ITEM: Consideration of Approval of a Deductive Change Order 10 to Marshall Brothers Construction and Engineering in the amount of \$-7,347.49 for the Phase I Improvements of the St. Andrews WWTF.

Date of Issuance:	8/16/2019	Effective Date:	
Owner:	City of Panama City	Owner's Contract No.:	308354
Contractor:	Marshall Brothers Construction and Engineering, Inc.	Contractor's Project No.:	308354
Engineer:	Mott MacDonald	Engineer's Project No.:	308354
Project:	St. Andrews WWTF Improvements Phase I	Contract Name:	St. Andrews WWTF Improvements

Change Order 10 Breakdown

11H SENSOR PROBE INSTALLATION

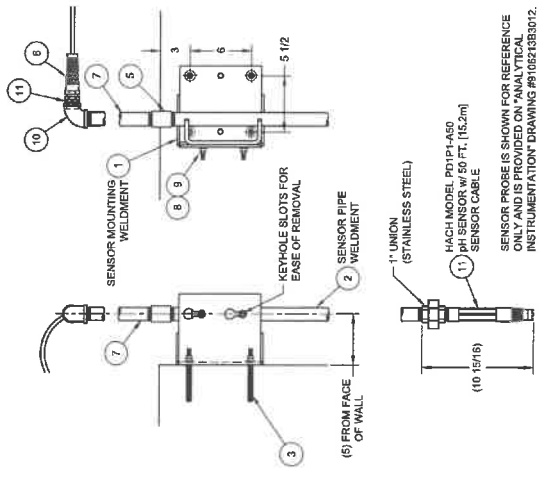
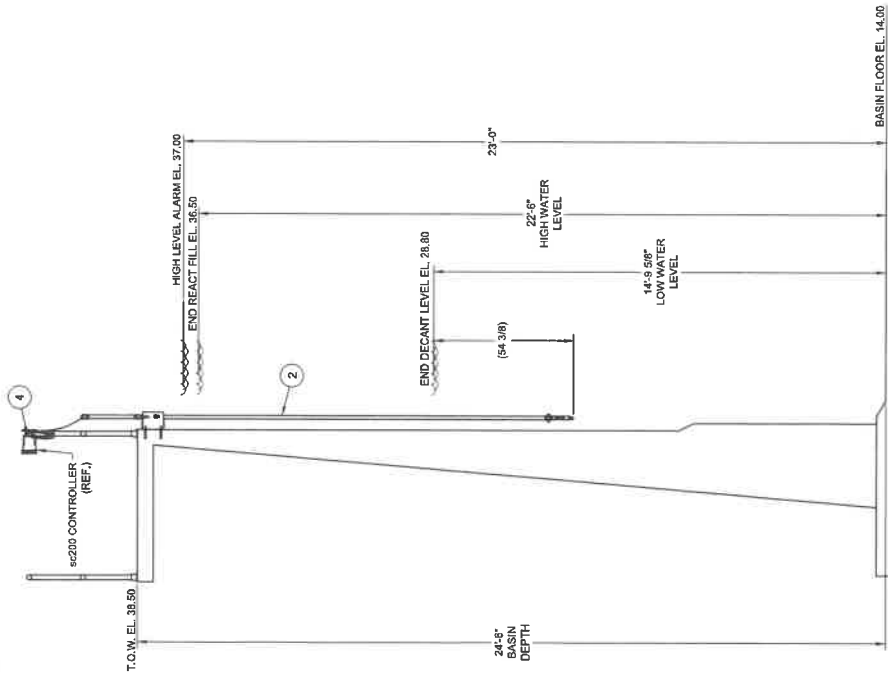
Description:
SEE BREAKDOWN ON PAGE 2
Attachments:
St. Andrews pH Drawing

Increase: Effluent pH monitoring system for permit compliance	\$23,261.50
Decrease: Remove additional activated charcoal carbon media for odor control from change order No.7	-\$4,200.00
Increase: Electrical for 2nd exhaust fan SBR3 Blower Build	\$4,825.00
Increase: 24"x36" Tap at headworks for highway 390 FM	\$50,250.00
Increase: Replace city damaged handrail	\$2,075.00
Increase: Run indication for odor control blower	\$2,700.00
Increase: Provide trending SCADA effluent sampling.	\$1,150.00
Decrease: Current Tax Savings on PO 2017-00002237 - AAG Services	-\$13,422.50
Decrease: Current Tax Savings on PO 2017-00002281 - Andritz Separation	-\$25,447.50
Decrease: Current Tax Savings on PO 2017-00001770 - Aqua Products Inc	-\$11,814.94
Decrease: Current Tax Savings on PO 2017-00001993 - GraybaR Electrical	-\$36,724.05
